ENGINE - INCORPORATION OF FIRE SHIELDS ON THE NO.1 STRUT FAIRING PANEL A/O - CATEGORY
CODE 3 - MOD.ENG-72-0024

V2500-ENG-72-0024

SERVICE BULLETIN

Rework of the No.1 Strut Fairing Panel A/O
Fig.2, Sheet 2 of 2

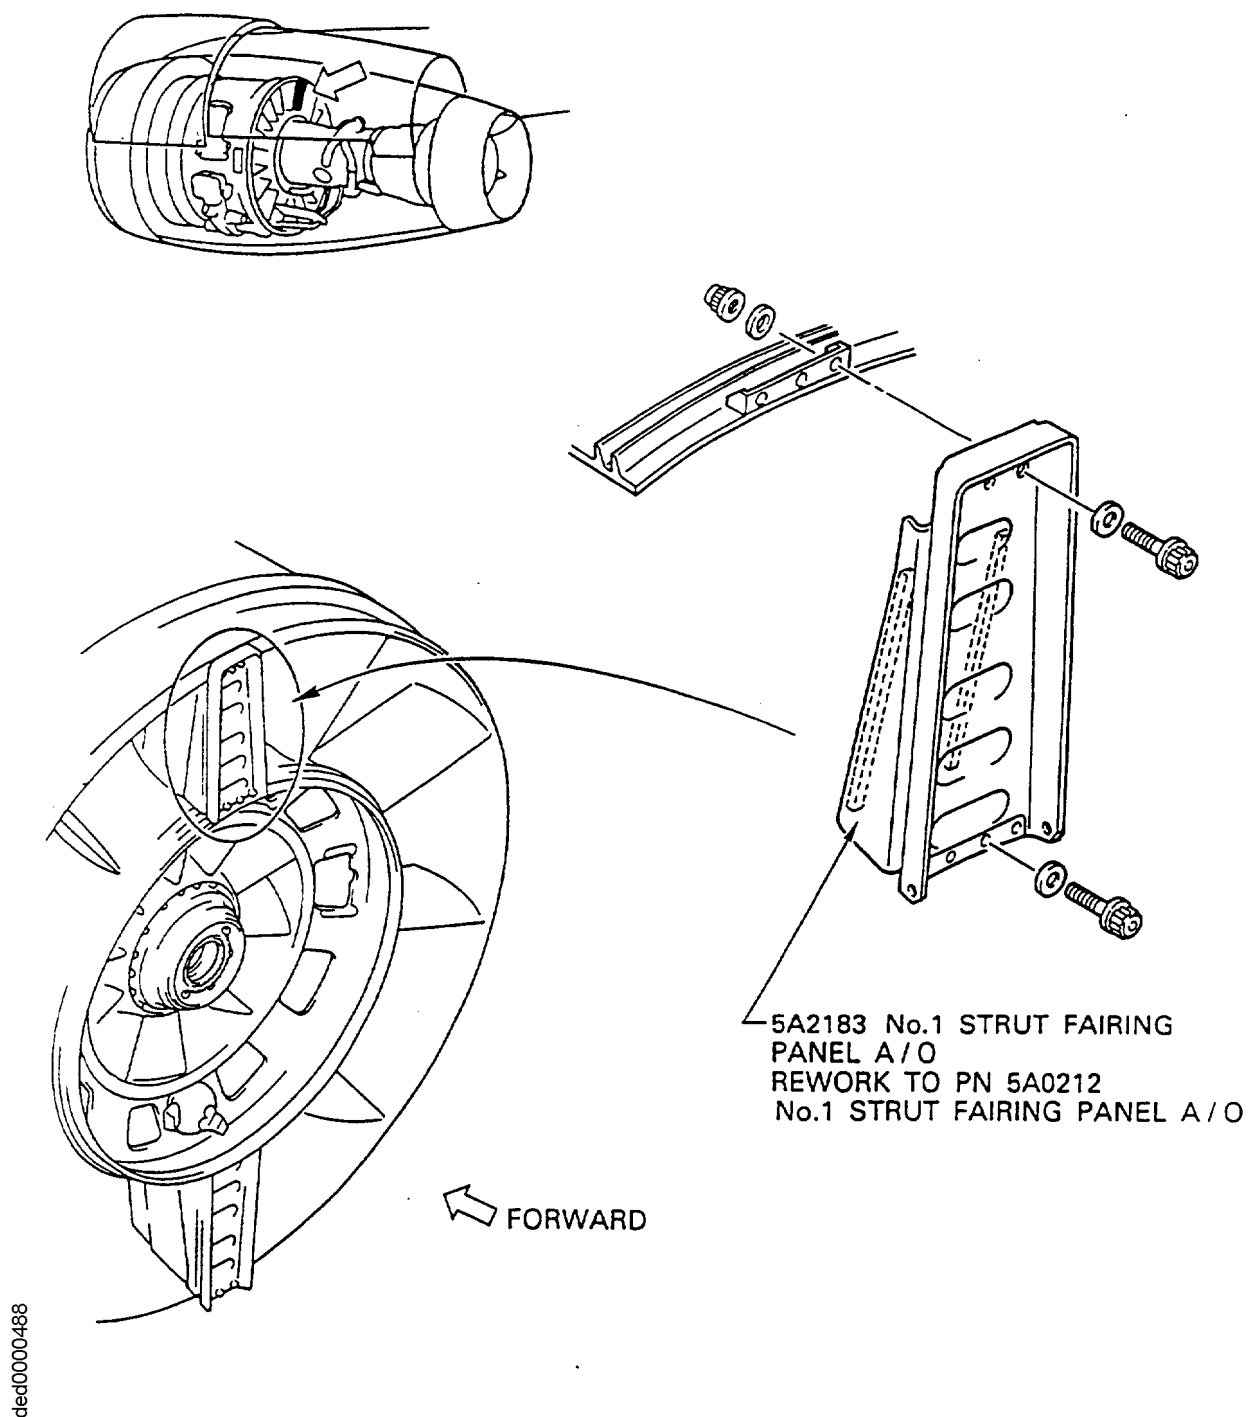
- (4) Remove all burrs from the holes in the Fire Shield and the Fairing Panel. (Refer to Figure 2, Sheet 1).
- (5) Remove only enough Bolts, Nuts, Washers and Strut Corner Fillers to peel back the Fairing Panel allowing access as follows: (Refer to Figure 2, Sheet 2).

- (a) Remove the three 4W0002, Nuts, 4W0166, Bolts, the six AN960C416, Washers, the four 4W0106, Bolts, and AN960C10, Washers.
 - (b) Remove the two 4W0104, Bolts, the two 4W2621, Washers, and 5A2126, LH Panel Corner Filler.

- (c) Remove the two 4W0104, Bolts, the two 4W2621, Washers, and 5A2127, RH Panel Corner Filler.
 - (d) Move the Fairing Panel rearwards to get access to the fore side of Fairing Panel.

- (7) Do steps B.(1), B.(2), B.(3), B.(4) and B.(6) again to install 740-0500-502, Fire Shield, on the inner right side of the Fairing Panel.
- (8) Put the Fairing Panel back to the Fan Frame and the Fan Case, and install the removed Bolts, Nuts, Washers and the Strut Corner Fillers as follows: (Refer to Figure 2, Sheet 2, and 1.K.(2), Aircraft Maintenance Manual, 70-23-11, Torque Tightening Technique, and 1.K.(4)).

- (a) Install the three 4W0166, Bolts, the six AN960C416, Washers, and the three 4W0002, Nuts, to safety the Fairing Panel and the Fan Case Bracket. Torque the Bolts to 85 – 100 lbfin (9,60 – 10,50 Nm).

- (b) Install the four AN960C10, Washers and 4W0106, Bolts, to safety the Fairing Panel and the Fan Frame. Torque the Bolts to 36 – 40 lbfin (4,07 – 4,52 Nm).

- (f) Apply CoMat 08-045, Sealant (RTV-103), to the mating surfaces of the two Panel Corner Fillers.
 - (g) Install 5A2127, RH Panel Corner Filler, with the two 4W2621, Washers, and the two 4W0104, Bolts. Torque the two Bolts to 36 – 40 lbfin (4,07 – 4,52 Nm).

- (h) Install 5A2126, LH Panel Corner Filler, with the two 4W2621, Washers, and the two 4W0104, Bolts. Torque the two Bolts to 36 – 40 lbfin (4,07 – 4,52 Nm).

Location of the No.1 Strut Fairing Panel A/O
Fig.1

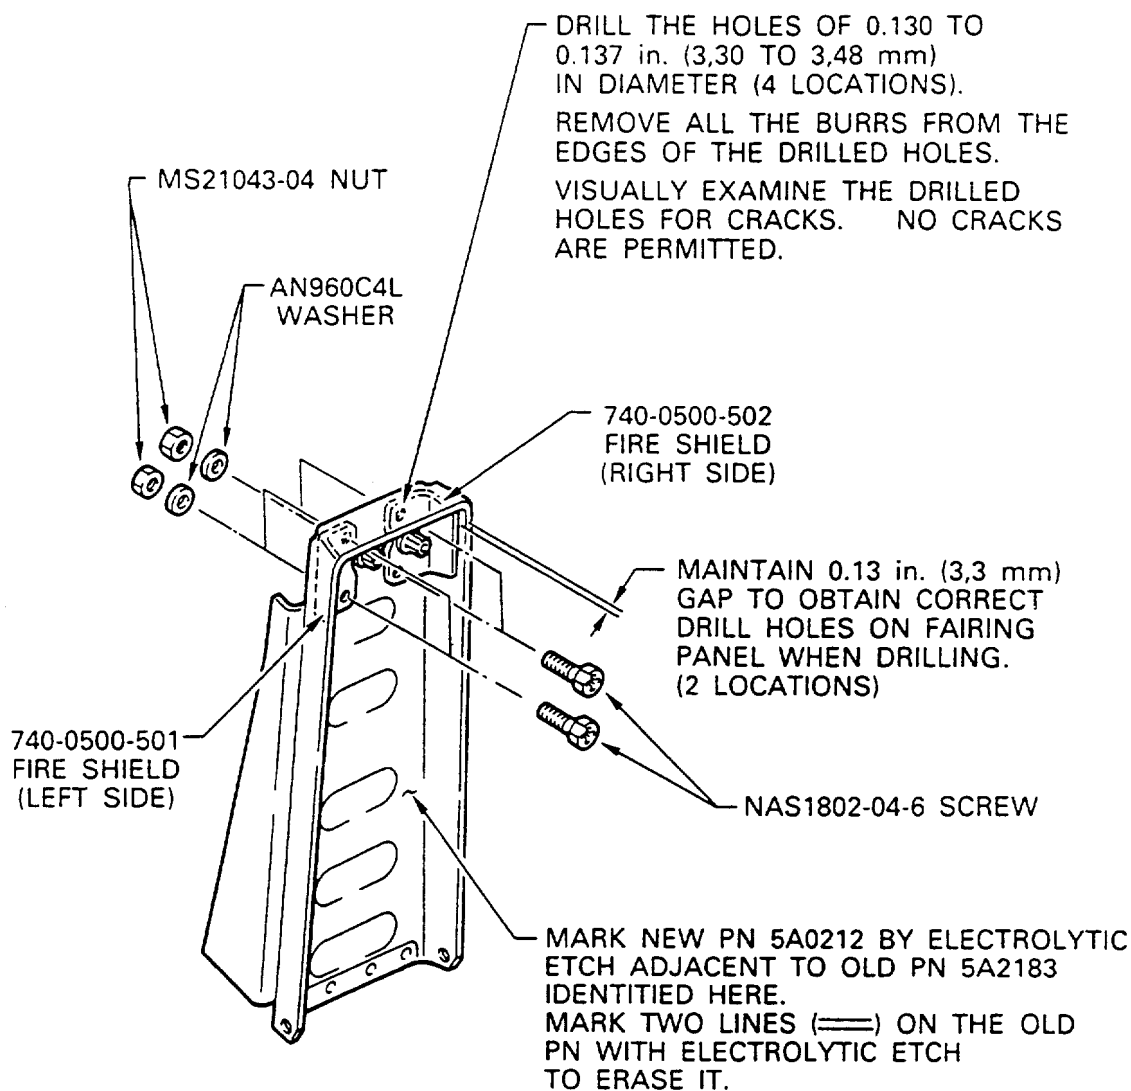
- (1) Find 5A2183, No.1 Strut Fairing Panel A/O on the Fan Frame No.1 Strut. (Refer to Figure 1).
- (2) Place 740-0500-501, Fire Shield over existing the Fairing Panel attaching Bolt on the inner left side of the Fairing Panel. Butt the Fire Shield with the top of the Fairing Panel and maintain a vertical gap of 0.13in. (3,3 mm.) between the Fairing Panel and the Fire Shield. Hold the Fire Shield with a clamp in position. (Refer to Figure 2, Sheet 1).

Rework of the No.1 Strut Fairing Panel A/0
Fig.2, Sheet 1 of 2

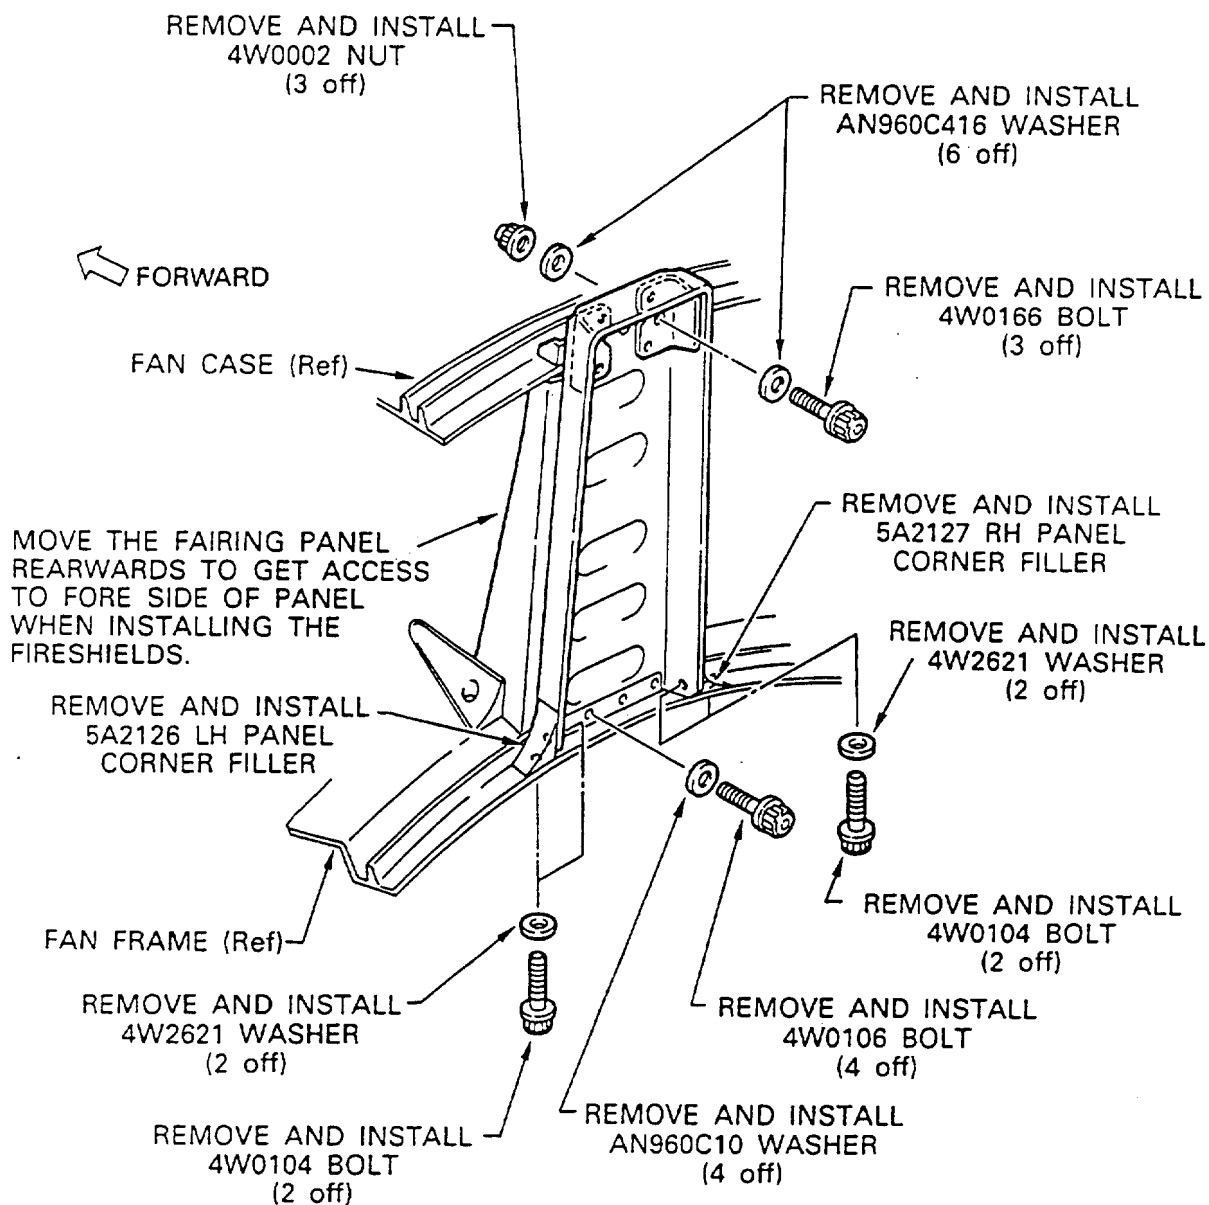
- (a) The Fire Shields and their attaching parts are being added to the No.1 Strut Fairing Panel (A/0), to provide the thermal protection for the Thrust Reverser Firewall Seal. (See Figure 2).
- (b) In agreement with the above, the No.1 Strut Fairing Panel (A/0) is reworked to include drilled holes which permit the installation of the Fire Shields on the Fairing Panel with the Screws, Nuts, and Washers. (See Figure 2).
- (2) The existing No.1 Strut Fairing Panel (A/0) can be reworked to a new configuration. (See Figure 2).
- (3) New No.1 Strut Fairing Panel (A/0) and Fire Shields including their attaching Screws, Nuts, and Washers will be available for future replacement purposes.

- (3) Drill two 0.130 to 0.137in. (3,30 to 3.48 mm.) diameter holes from two pilot holes in the Fire Shield through the Fire Shield and the Fairing Panel. Remove the clamp, and keep the Fire Shield. (Refer to Figure 2, Sheet 1).

- (6) Attach 740-0500-501, Fire Shield to the Fairing Panel with two NAS1802-04-6, Screws, AN960C4L, Washers, and MS21043-04, Nuts. Torque the Nuts to 6 – 7 lbfin (0,68 – 0,80 Nm). (Refer to Figure 2, Sheet 1 and 1.K.(2), Aircraft Maintenance Manual, 70-23-11, Torque Tightening Technique).

- (9) Renumber by the Electrolytic etch adjacent to the existing Part Number on the Fairing Panel as follows. (Refer to Figure 2, Sheet 1, and 1.K. (3)).
